802 3rd Street, Suite 224
Douglas, Alaska 99824
Main: 907.465.6014
Email: Michael.lim@alaska.gov

Addendum # Three (3)

1. Specification Section 08 53 13 Vinyl Windows
2. Specification Section 23 05 93 Testing, Adjusting, and Balancing for HVAC
3. Mechanical EF-2
4. Attached is the plan holder list for this project (8 pages). The company name that are highlighted in yellow attended the mandatory pre-site visit.

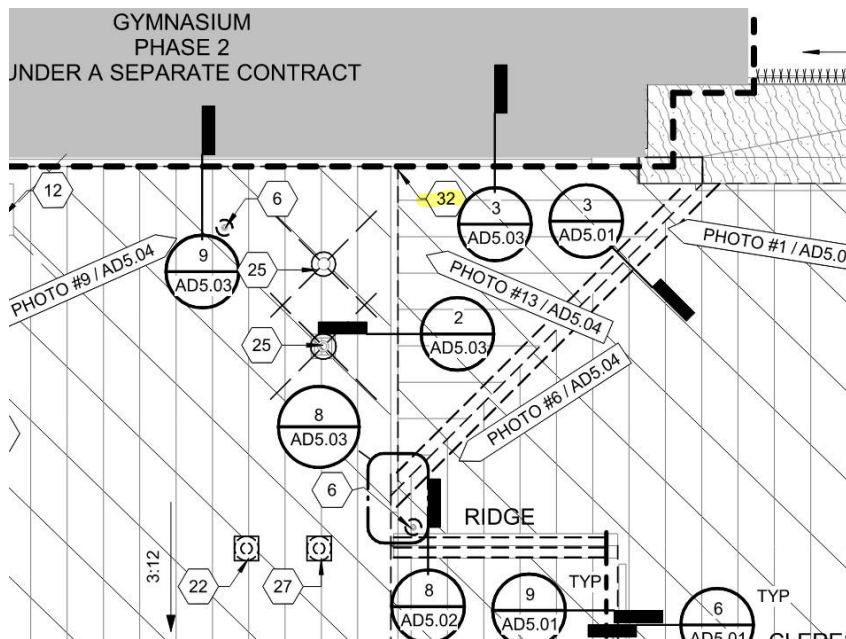
16. Phase 1 – Detail 1/AD5.02 includes a note stating “*Demo (E) plywood soffit panel.*” However, the details provided for the new work indicate that this plywood soffit is to remain. Which is correct?

DOC Response: *Existing plywood is to remain to the extent possible to accomplish required new work detailed.*

2 AIR HANDLER HOOD DETAIL

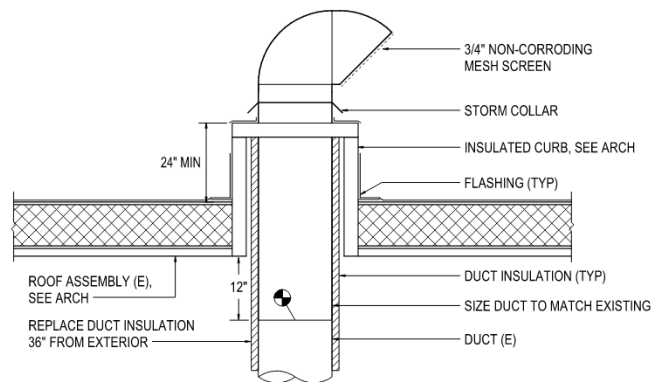
4 on Sheet A5.03 provide the new flashing requirements associated with this existing mechanical duct/curb. But the curb construction appears to be drawn in dark linework, which eludes to the fact that the curb would need to be demolished and replaced, however there are no construction details or direction provided to support the need to reconstruct this curb. There is a note in Detail 4/A5.03 stating “*Typical mechanical curb, see.*” Meanwhile, Sheet M2.11 identifies this same mechanical duct and refers you to Detail 2/M0.21 which does not appear to exist. In summary, please clarify the requirements associated with whether a new wood-framed architectural curb and/or steel pre-manufactured mechanical curb are required, along with any demolition efforts associated.

DOC Response: *Keynote 112 should also include reference to constructing a new curb. The referenced mechanical detail is shown as part of the Phase 2 drawing set and is shown below. Curb is to be demolished and a new curb per the referenced detail is to be provided/constructed. See response to question 20 for specific curb construction.*

Reference to detail 2/M0.21 was inadvertently left out of phase 1 drawings. This detail is hereby incorporated into Phase 1 drawings and show below:

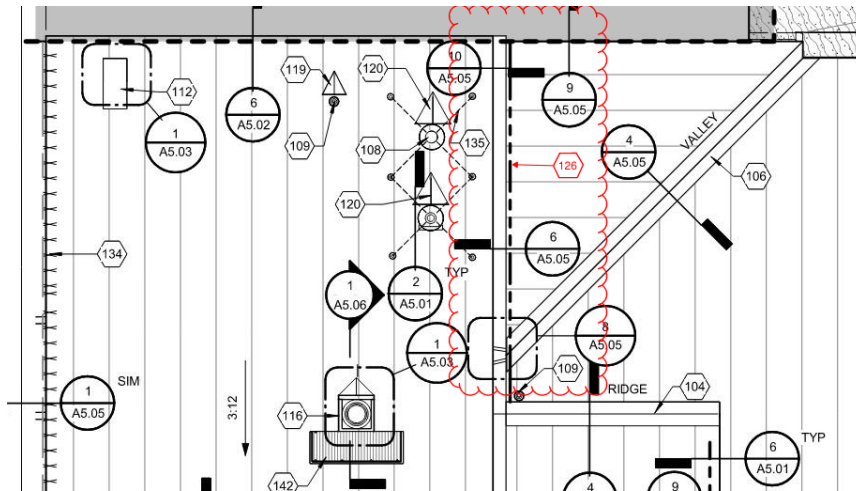
24. Phase 1 – Keynote 122 on Sheet A1.02 states “Repair decking from abandoned penetrations this area.” There is a detail reference at one of the Keynote 122 callouts which refers you to Detail 9/A5.03. This detail does not appear to apply to the condition in question. Please advise.

DOC Response: *Section detail 9/A5.03 is unrelated to keynote 122 as questioned. Detail reference is intended to indicate the construction occurring at the nearby rake condition. Note the reference should be changed to read 10/A5.04 given the condition at this location does not include new metal siding installation.*

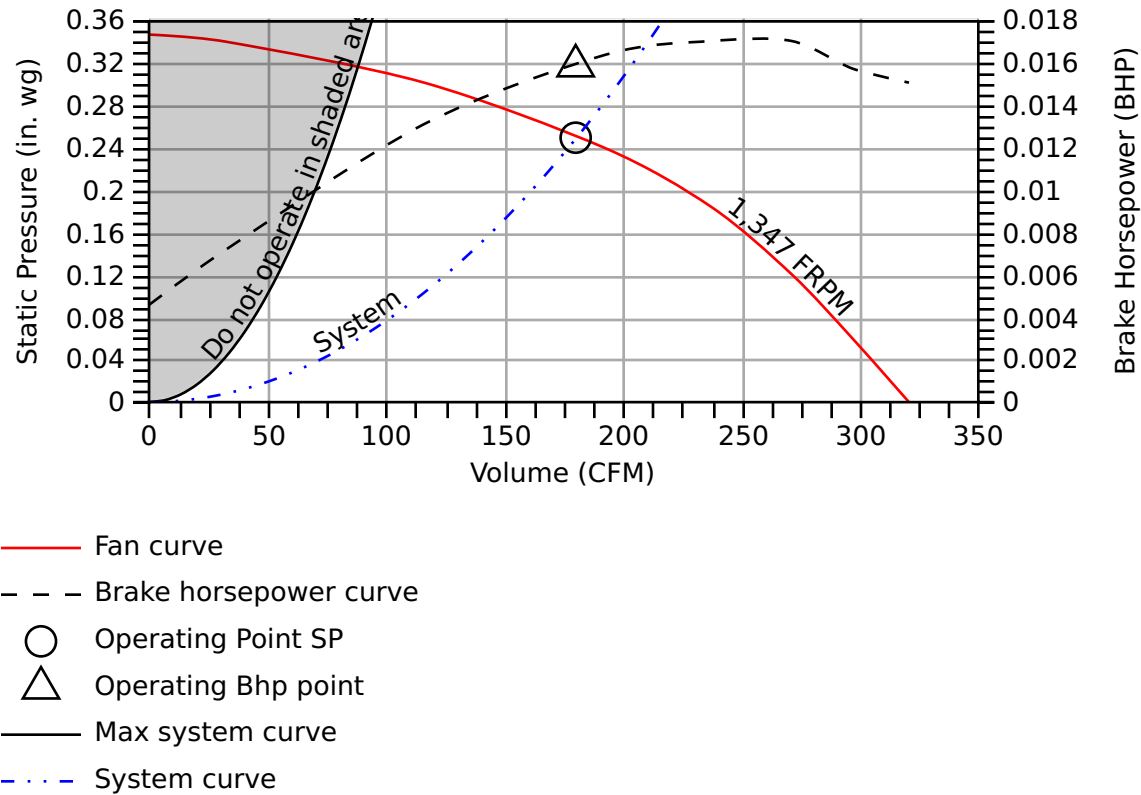
79. We cannot measure CFMs on upblast fans at the discharge, they will require a duct traverse if a suitable location is available or reading of all the attached grilles to obtain the fan totals. If TAB is required, are there any mechanical plans that show the interior duct work and grilles with CFMs for these fans?

DOC Response: *There is an existing duct in the fan room connected to sidewall (upblast configuration) fan EF-2 that could be used for a duct traverse. Duct size to be field verified.*
